**BEFORE THE HEARINGS PANEL
FOR THE PROPOSED QUEENSTOWN LAKES DISTRICT PLAN**

IN THE MATTER of re-notified Stage 1
submissions: Gertrude's
Saddlery Limited and
Larchmont
Developments Limited,
at Arthurs Point

**REBUTTAL EVIDENCE OF HELEN JULIET MELLSOP
ON BEHALF OF QUEENSTOWN LAKES DISTRICT COUNCIL**

20 DECEMBER 2022

Figure 1: Proposed LLRB Structure Plan overlaid on Appendix D of my EiC.

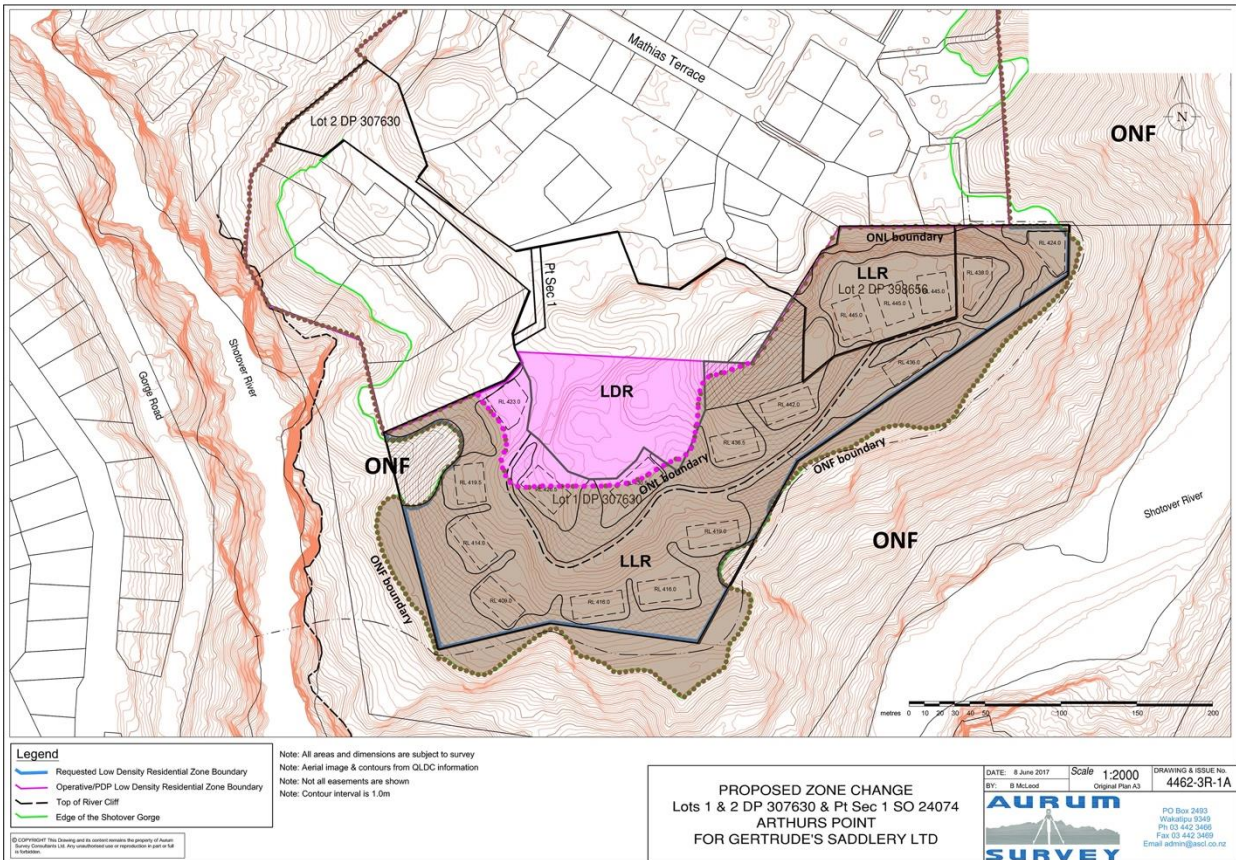
3.3 **Figure 1** below shows the differences between the two LDRZ areas (ie that in my primary evidence in pink, and that now proposed by the submitters with the black boundary). For the reasons set out in my primary evidence, I could support the revised extent of LDRZ sought by the submitters from a landscape perspective.
